**NRC Staff Comments on FAQ 12-0061, Revision 0 [CEM, HTB, SCD] {September 2012}**

## 5.3 Plant Change Process

Figure 5-1 – Fire Protection Change Impact Review Process

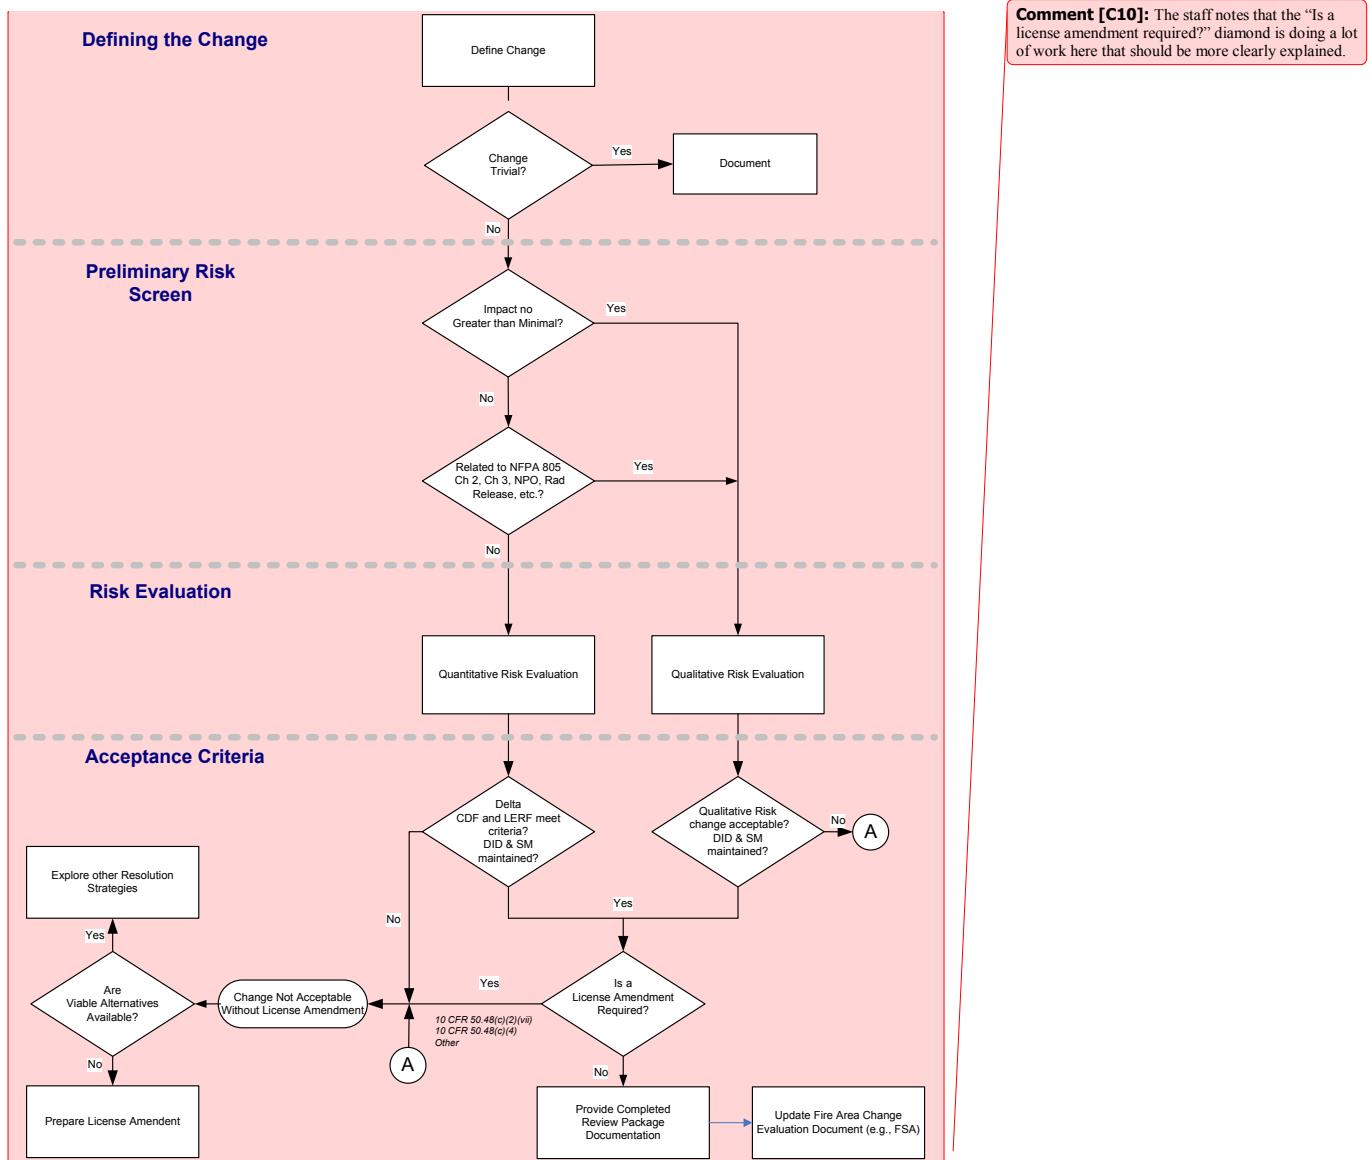
**Comment [S9]:** What is “minimal”? Suggest the 50-59 language that if unclear that it is an increase or decrease, it is minimal. 10-7/yr is not a definition of minimal since quantitative risk results are compared to this value.

Figure J-1 – Fire PRA Treatment of Cumulative Risk

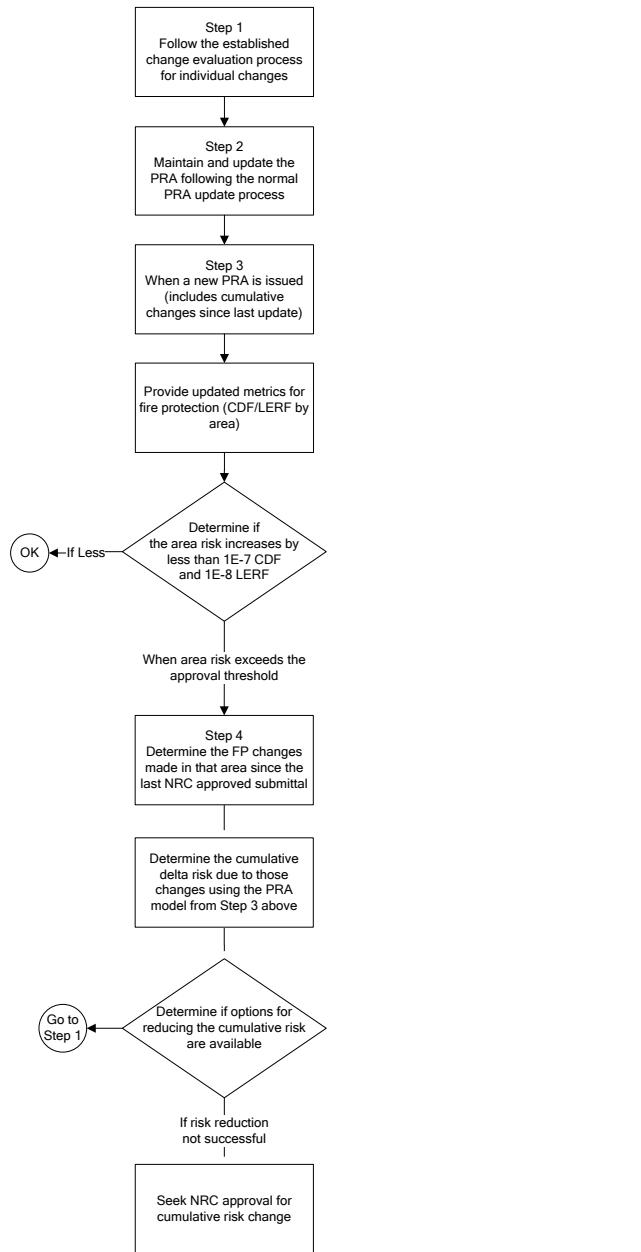
**Comment [S46]:** To be done in addition to the change process calculations?

**Comment [S47]:** This is to be done independently and in lieu of any specific change request?
